Project: ISLAND VIEW APARTMENTS  
 Date: SEPTEMBER 13, 2001  
 Scale: N.T.S.

Title: EXHIBIT/DIMINUS CHANGE- SANITARY SEWER BUILDING B TOWNHOUSE UNITS  
 REVISED OCTOBER 11, 2001  
 Date: OCTOBER 3, 2001  
 Scale: 1"=30'

Title: DIMINIMUS CHANGE REQUEST BUILDING A

Title: DIMINIMUS CHANGE REQUEST BUILDING B		DATE OF APPROVAL
Date: AUGUST 10, 2001	Scale: 1"=30'-0"	AUG 22 2001
Drawn By: JP	Checked By: RM	3
Project: ISLAND VIEW APARTMENTS

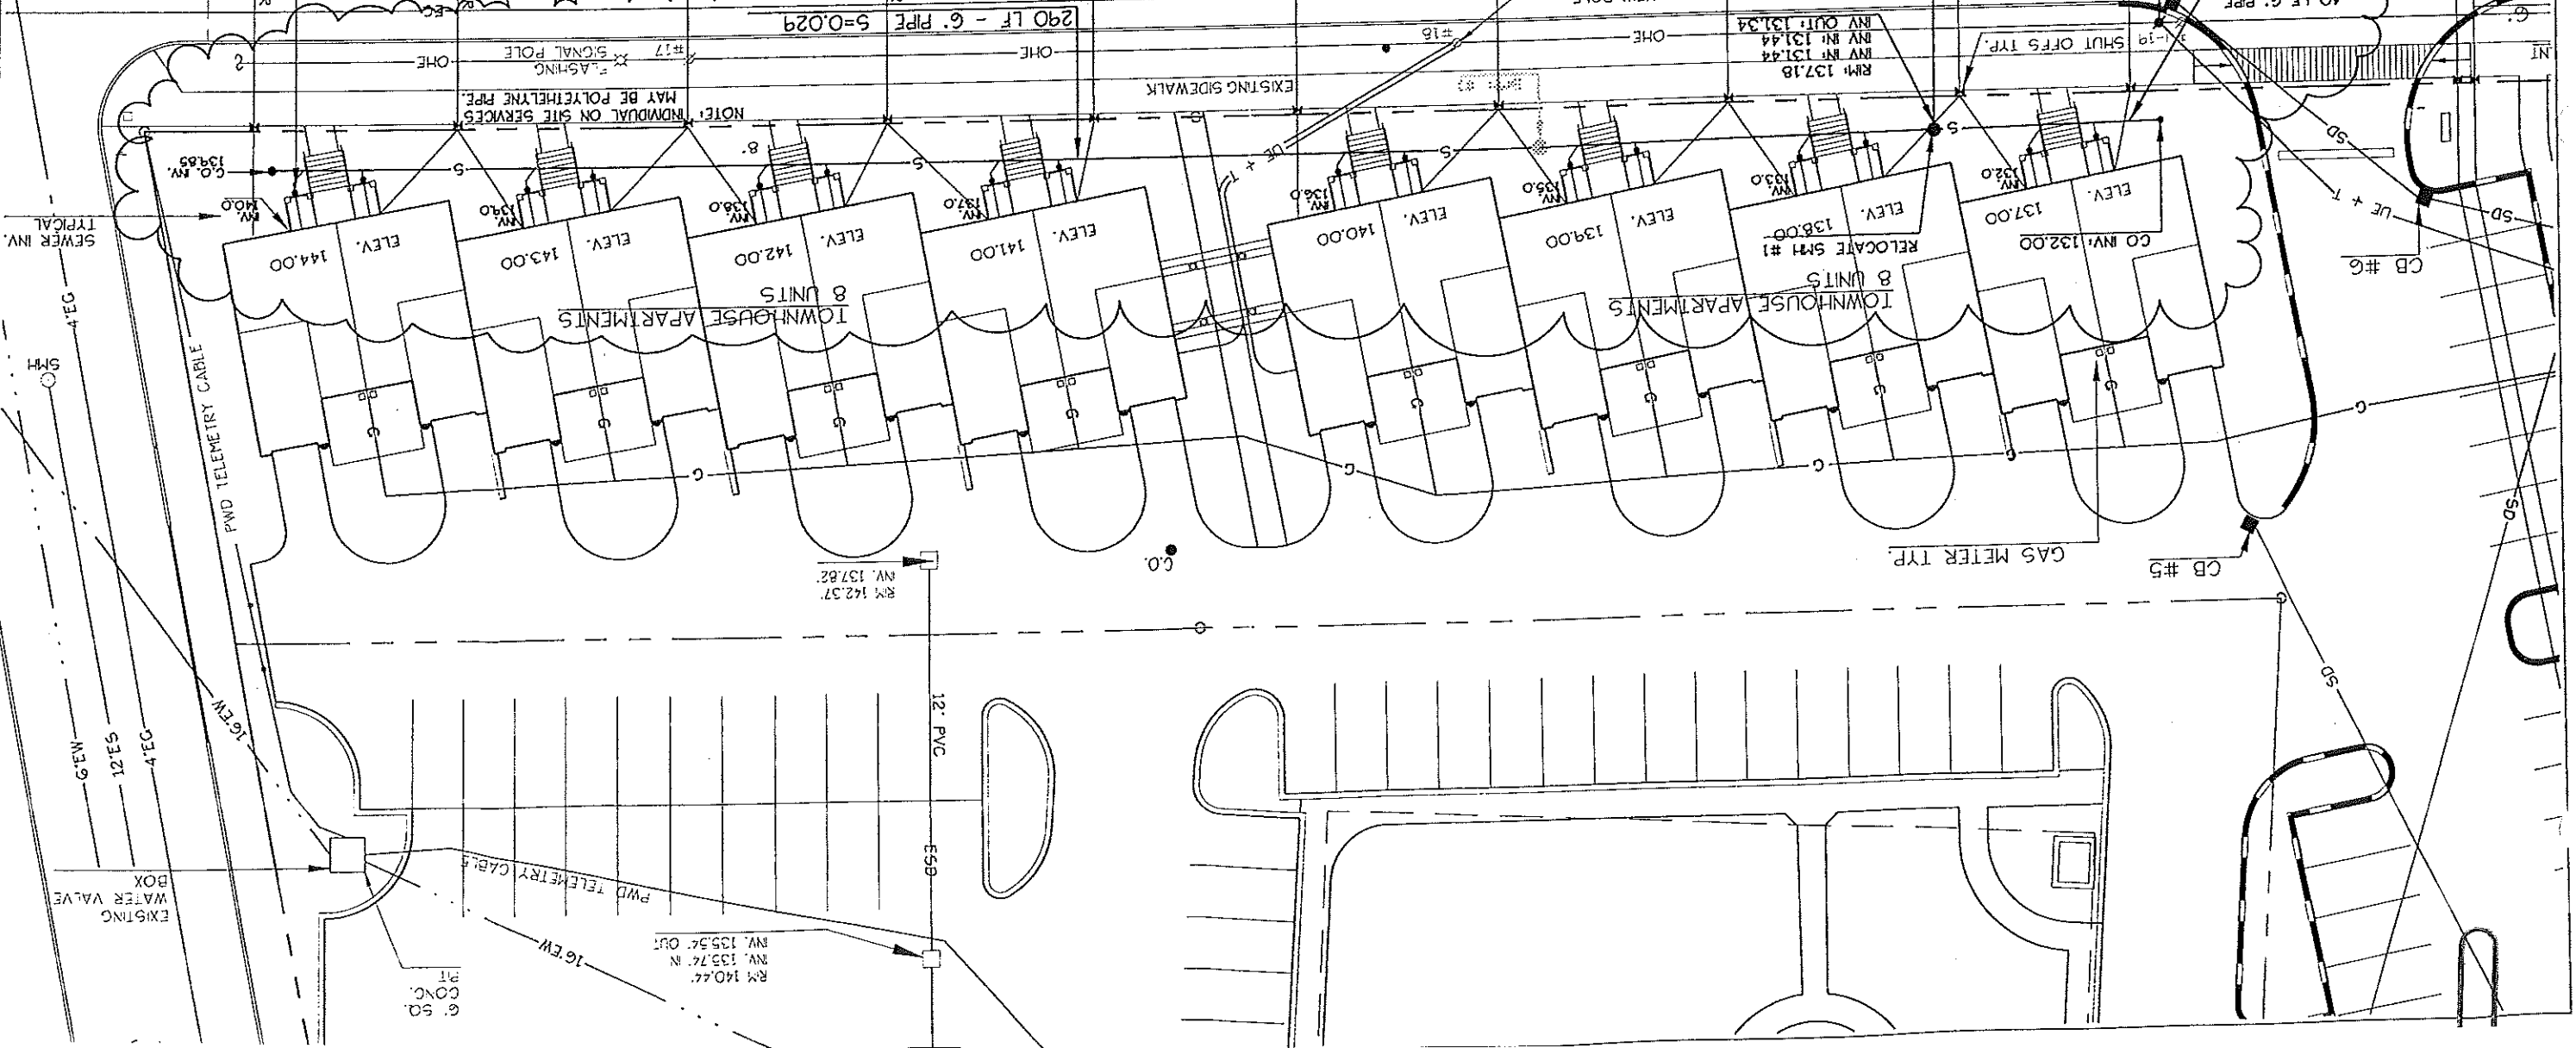
NOTE: ALL UNIT SERVICE CONNECTIONS SHALL BE WYE CONNECTIONS GREATER THAN 90 DEGREES.

WATERMAN TO BE UPGRADED TO 8" SERVICE (PORTLAND WATER DISTRICT TO INCREASE TO 12" SERVICE)  
 RMH 1A RMV 127.06  
 RMV 134.79  
 (CONTRACTOR TO VERIFY AND ADJUST AS NECESSARY)

APPROXIMATE END OF SANITARY SEWER EXISTING HYDRANT  
 EXIST. 12"x6" REDUCER  
 12"EW  
 1" WATER  
 (2) 1" WATER  
 PROVIDE CLEANOUT AT EACH SERVICE TYPICAL SEE NOTE 13.

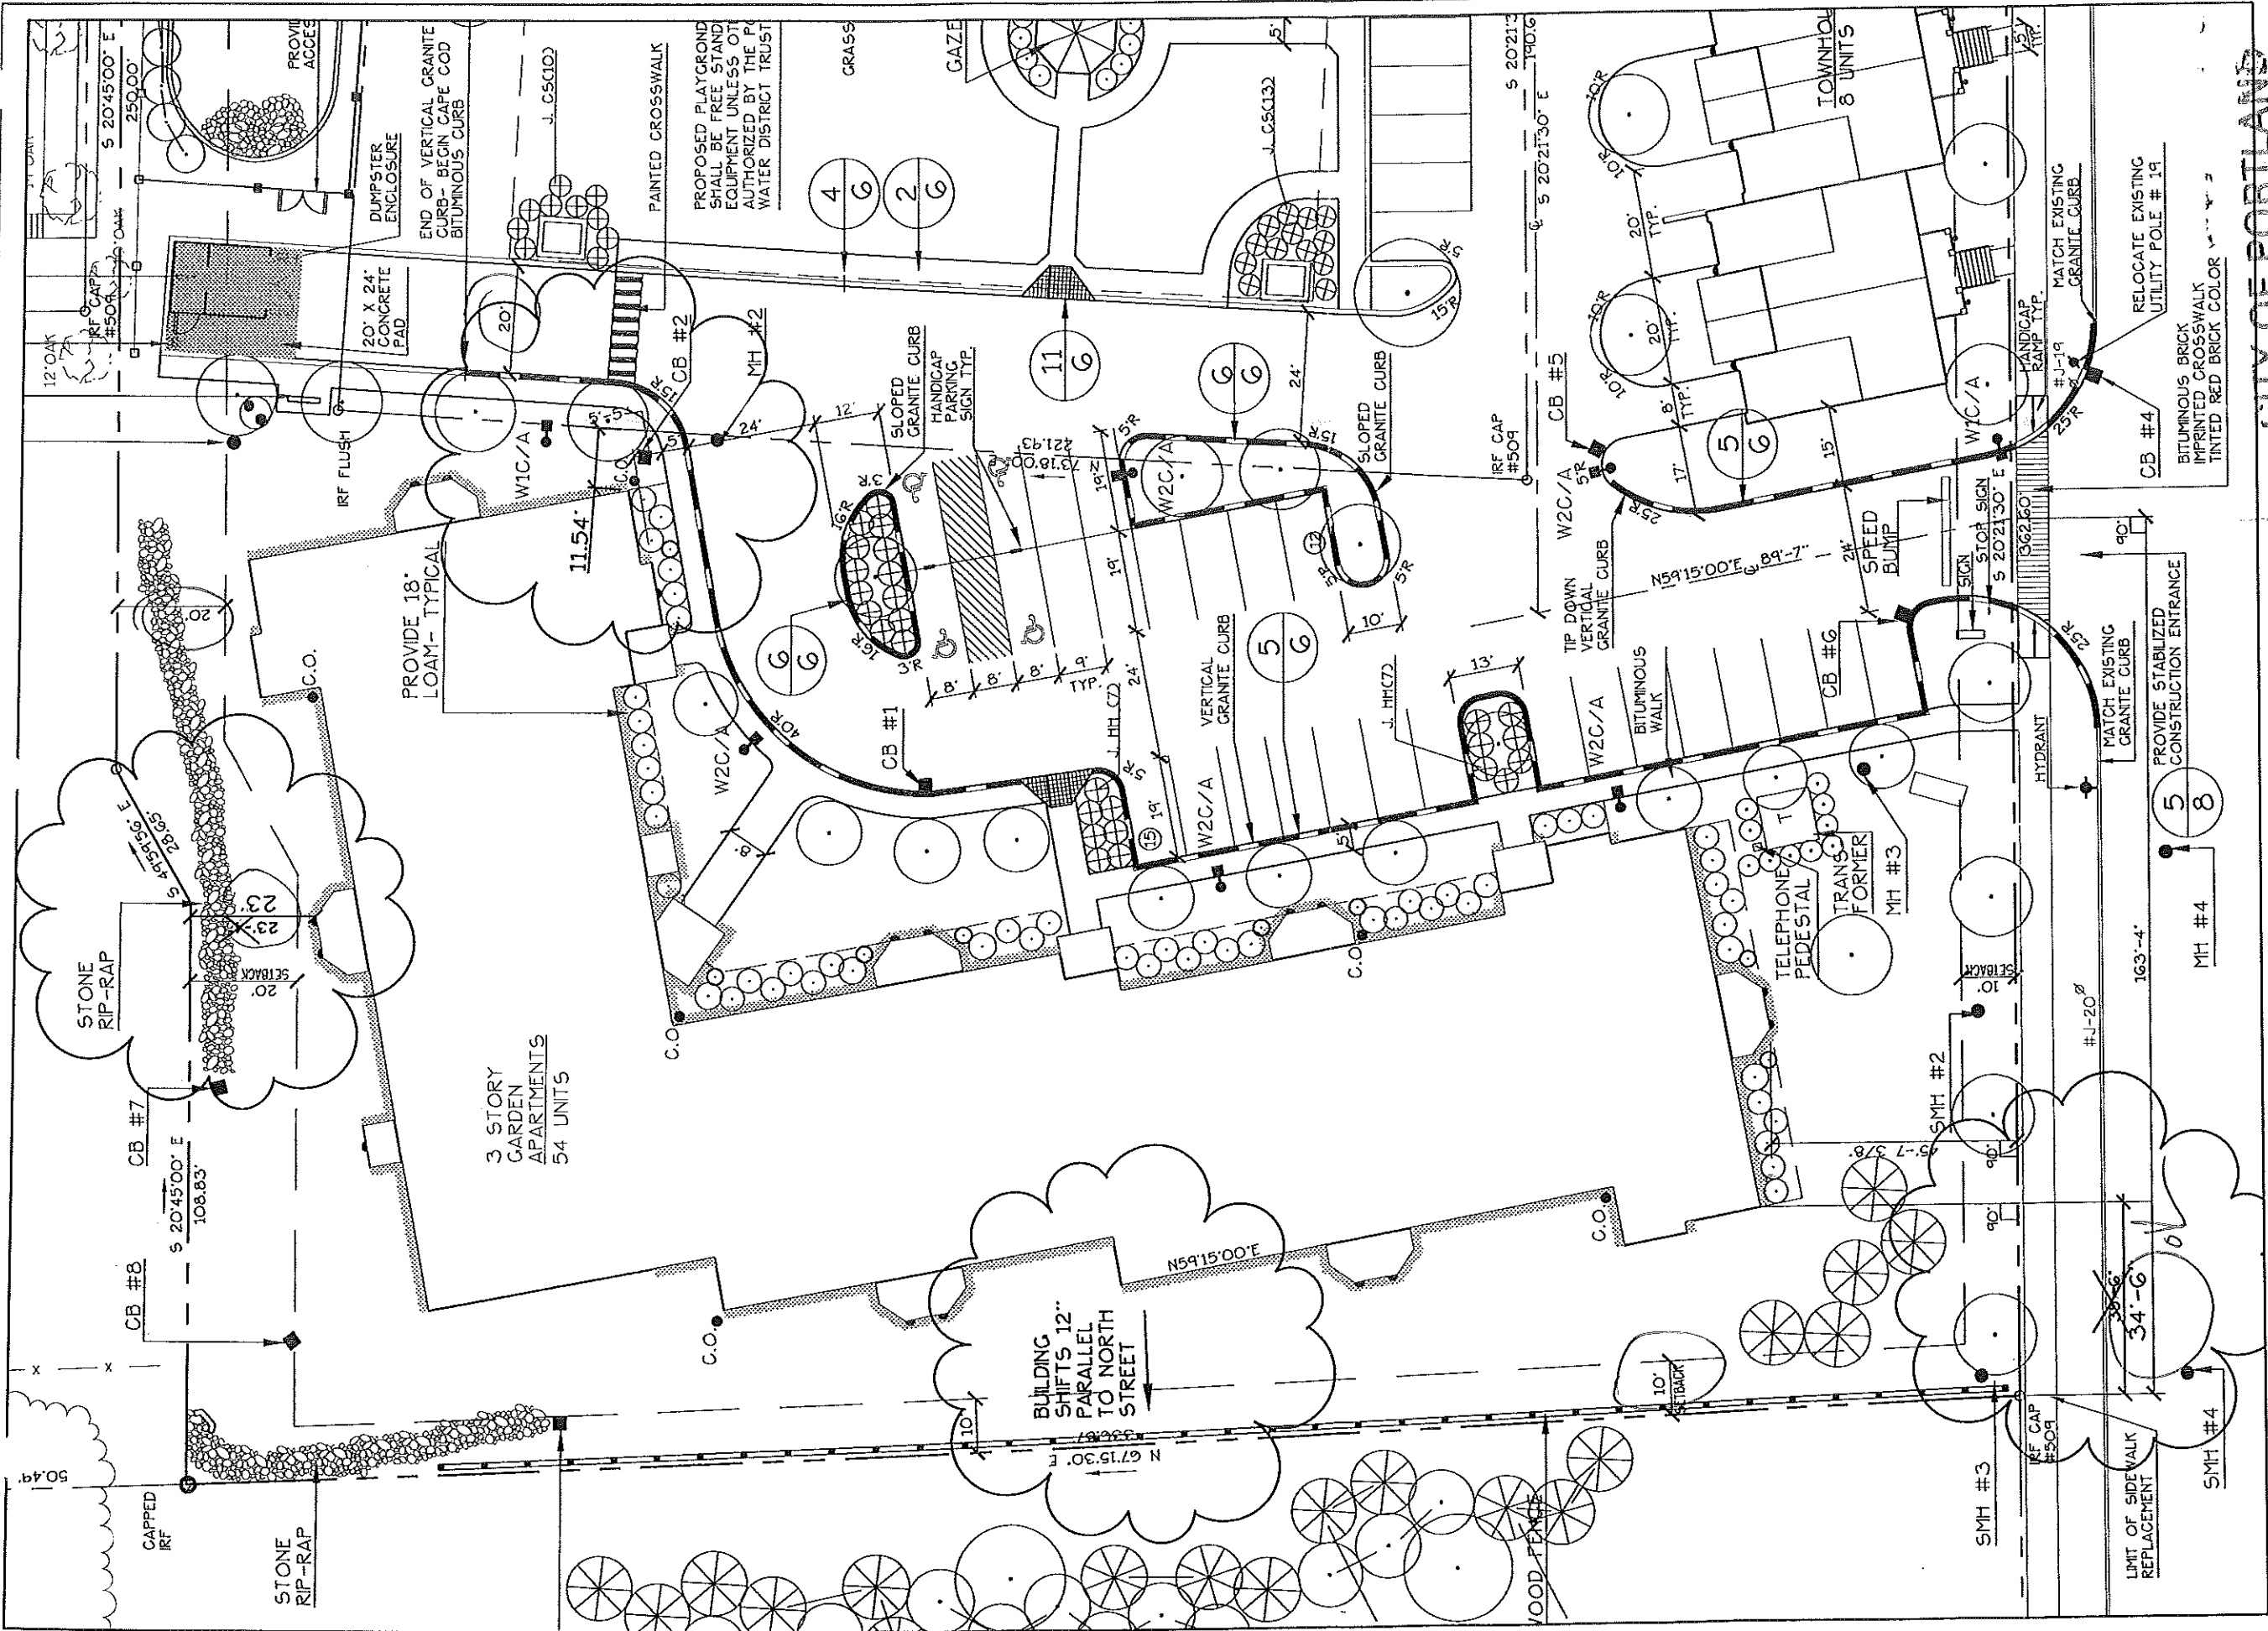
BUILDING A SHIFTED 1 FOOT TO THE NORTHWEST, PARALLEL TO NORTH STREET TO COMPLY WITH CITY OF PORTLAND REQUIREMENTS. SETBACK IS NOW 11.54 FEET.

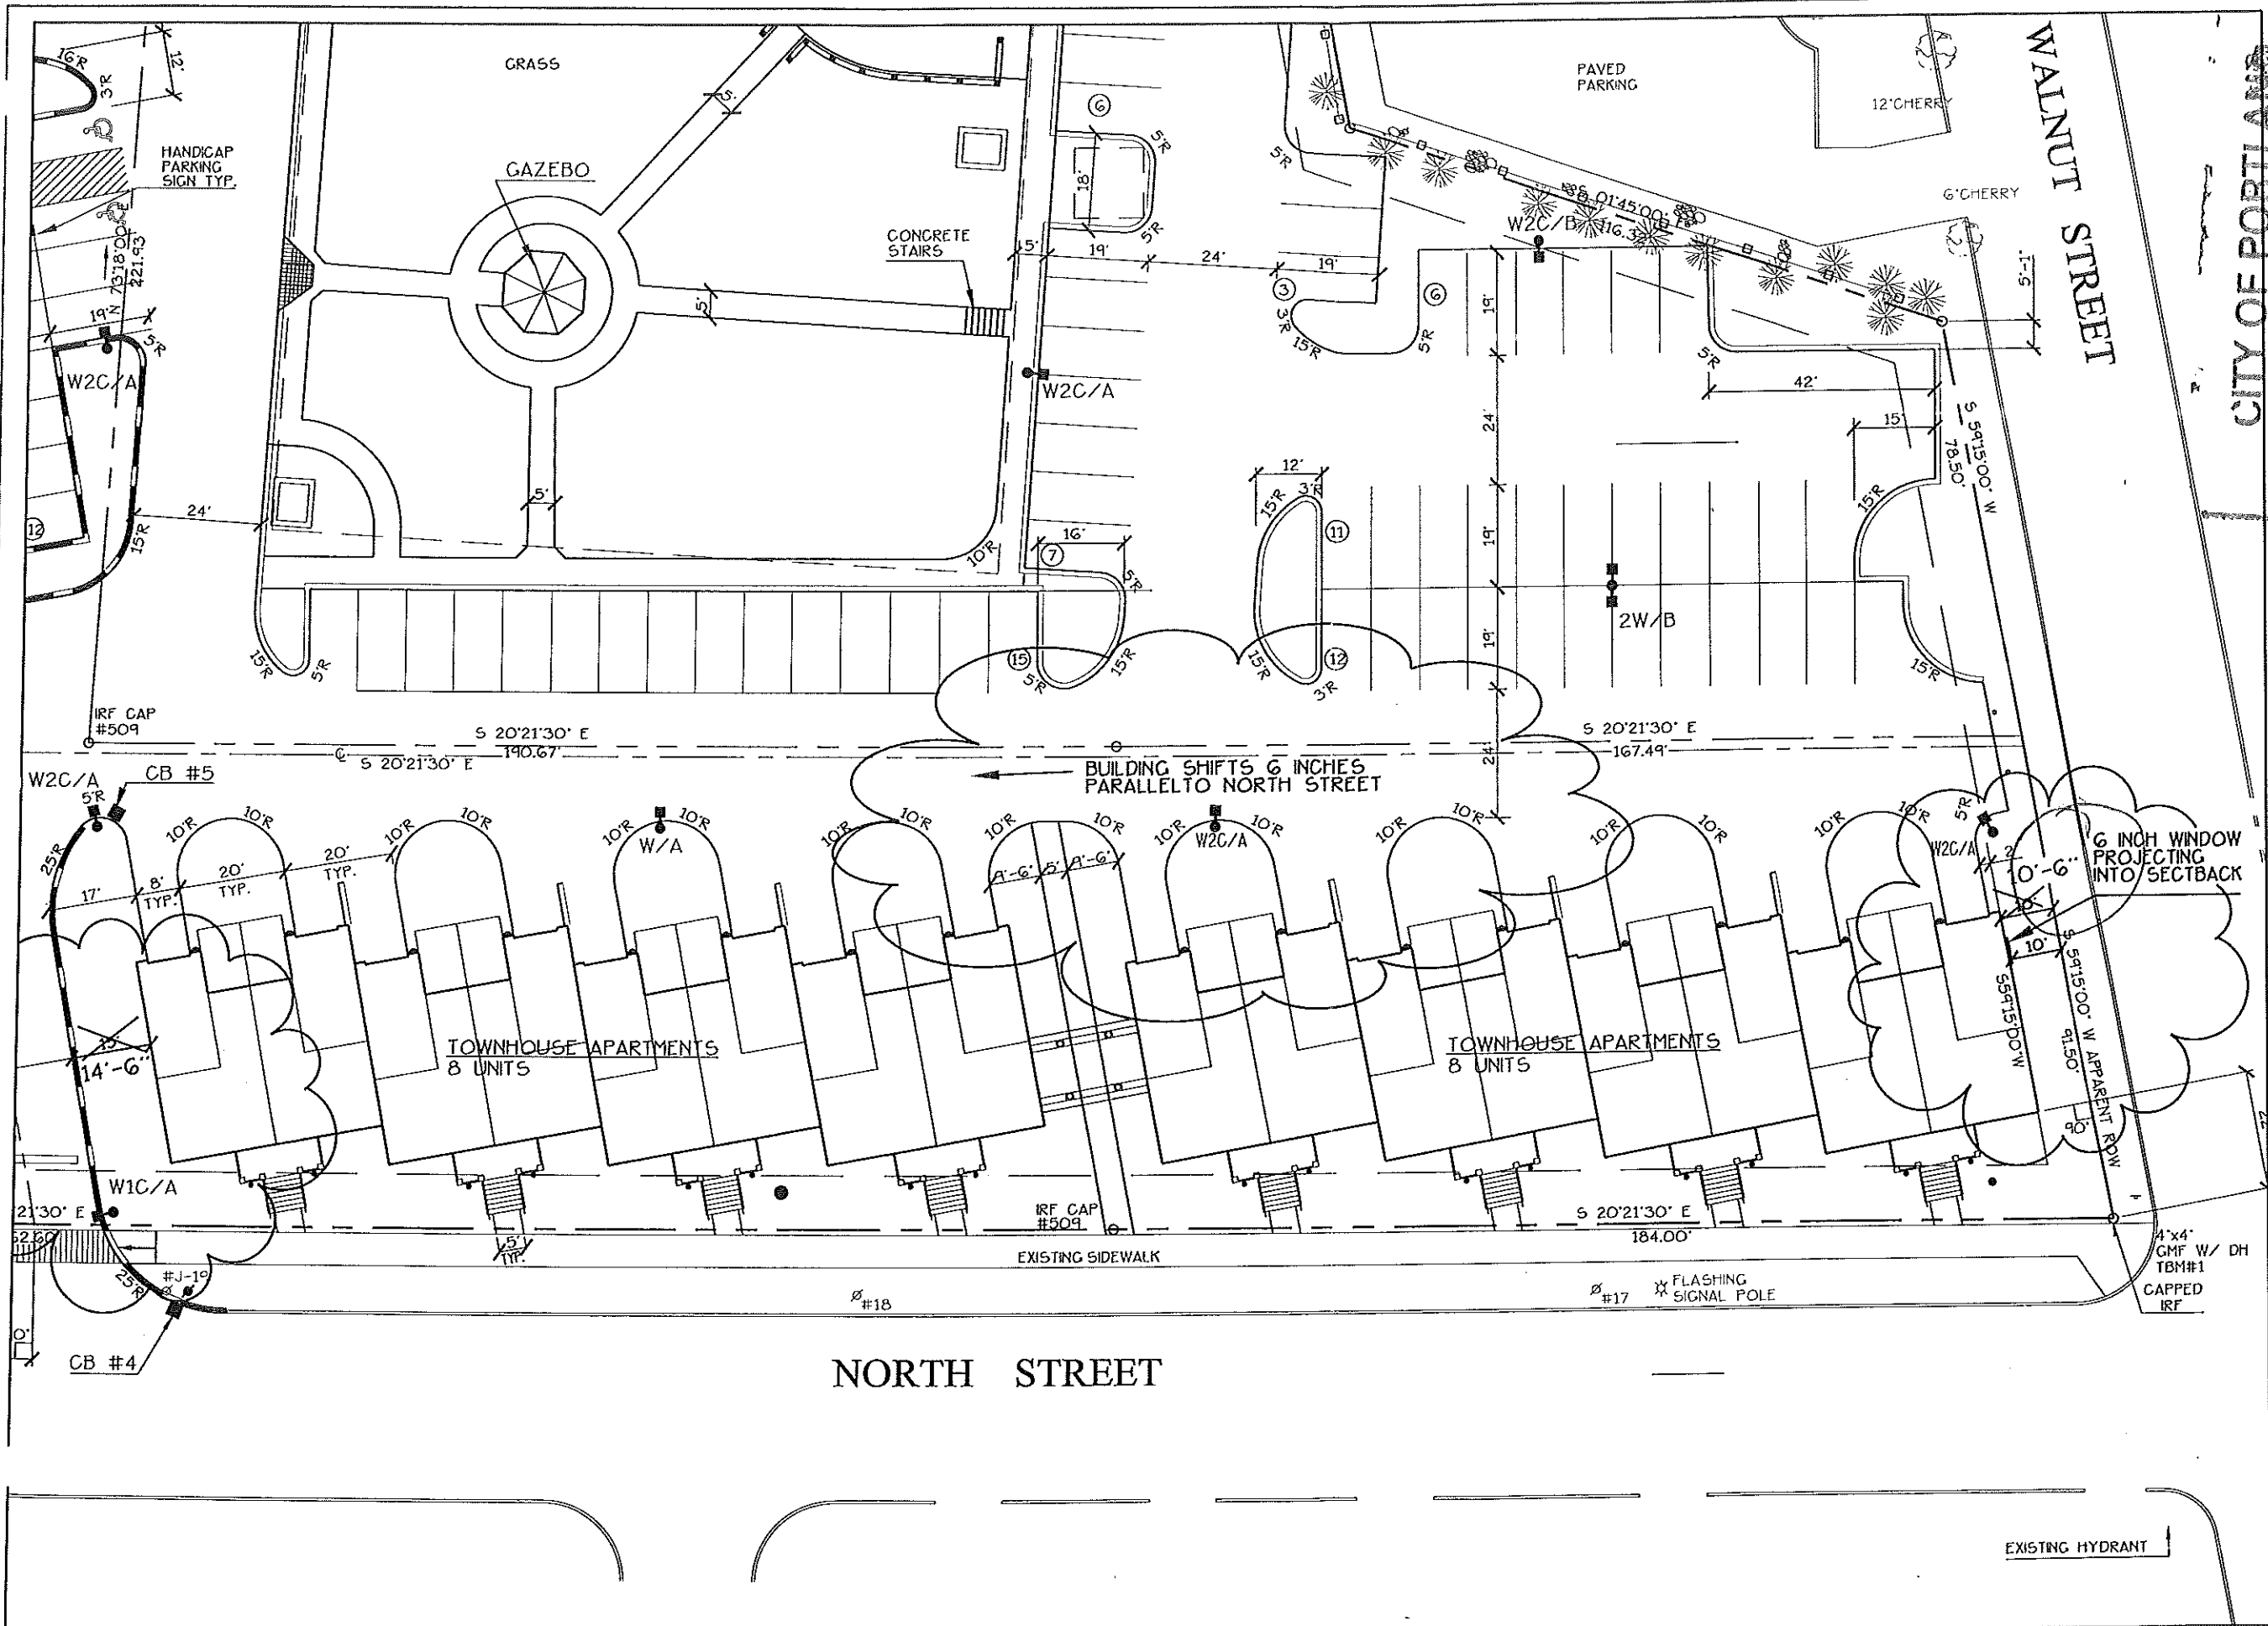
**BUILDING B SHIFTED 6 INCHES TO THE NORTHWEST, PARALLEL TO NORTH STREET TO COMPLY WITH 10 FOOT SETBACK FROM WALNUT STREET FOR A WINDOW PROJECTION.**
